Agenda Item #: 5
SUB-002586-2023

Athey Place Subdivision

- Subdivision approval to create five (5) legal lots from one (1) existing metes-and-bounds parcel.

APPLICATION NUMBER 5 DATE August 17, 2023

DETAIL SITE PLAN

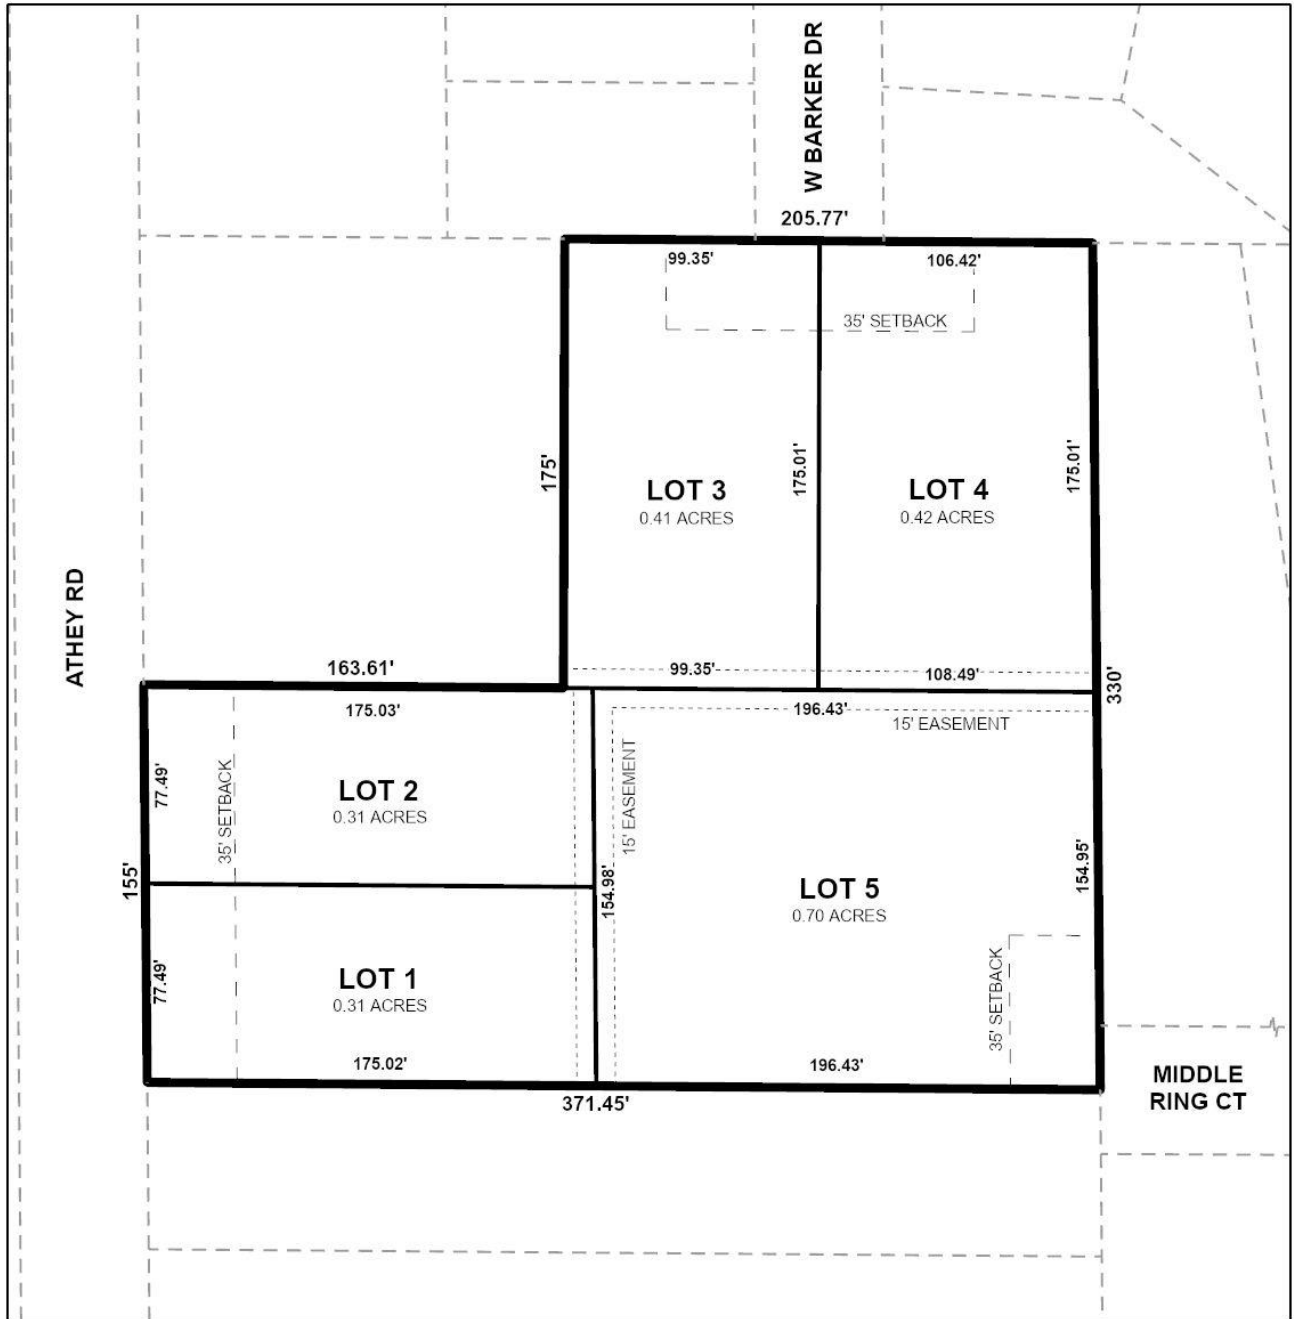
- D. Dedicate Public ROW for one half of a permanent turnaround at the west end of Middle Ring Ct. (cul-de-sac or hammerhead as approved by City Engineer). Coordinate the layout and dimensions with Engineering Dept. and the current requirements of the International Fire Code.

The subject site has linear frontage on Athey Road, a minor street with curb and gutter, and a compliant 50-foot right-of-way; therefore, no dedication would be required along Athey Road. The site also has closed-end frontage on Barker Drive West and Middle Ring Court. The plat should be revised to label all abutting streets with their right-of-way widths and the plat should be revised to correctly label Barker Drive West as such, not as West Barker Drive.

As per Section 6.B.3 of the Subdivision Regulations, a turnaround is required for new lots at the end of a closed-end street. As per the Engineering comments, a public right-of-way for one-half of a permanent turnaround should be dedicated at the west end of Middle Ring Court (cul-de-sac or hammerhead as approved by City Engineering). The layout and dimensions are to be coordinated with the City Engineering Department and the current requirements of the International Fire Code. No turnaround is required at the Southern terminus of Barker Drive West due to its short length.

A minimum building setback line of at least 25 feet should be retained along Athey Road for Lots 1 and 2, and from the South terminus of Barker Drive West for Lots 3 and 4 on the Final Plat. The plat should be revised to indicate a minimum building setback line of at least 25 feet as measured from any required turnaround dedication for Lot 5 at the end of Middle Ring Court.

The subject site is served by public water and sanitary sewer services, and the proposed lots exceed the minimum size requirements of Article 2, Section 64-2-5.E. of the Unified Development Code for lots in an R-1, Single-Family Residential Suburban district. As on the preliminary plat, the lot size labels in both square feet and acres should be retained on the Final Plat, revised for any required dedication, or a table should be furnished on the Final Plat providing the same information.

All proposed lots contain drainage and utility easements; therefore, a note should be required on the Final Plat stating that no structure may be constructed or placed within any easement without the permission of the easement holder, if approved.

1. Dedication and construction of one-half of a permanent turnaround at the end of Middle Ring Court, with the layout and dimensions to be coordinated with the Engineering Department and the current requirements of the International Fire Code;

2. Revision of the plat to correctly label Barker Drive West instead of West Barker Drive;
3. Revision of the plat to label all abutting streets with their right-of-way widths;

4. Retention of at least a 25-foot minimum building setback line along Athey Road for Lots 1 and 2, and from the South terminus of Barker Drive West for Lots 3 and 4;

5. Revision of the plat to indicate a minimum building setback line of at least 25 feet as measured from any required turnaround dedication for Lot 5 at the end of Middle Ring Court;

6. Retention of the lot size labels in both square feet and acres on the Final Plat, adjusted for any required dedication, or the furnishing of a table on the Final Plat providing the same information;

7. Placement of a note on the Final Plat stating that no structure may be constructed or placed within any easement without the permission of the easement holder;
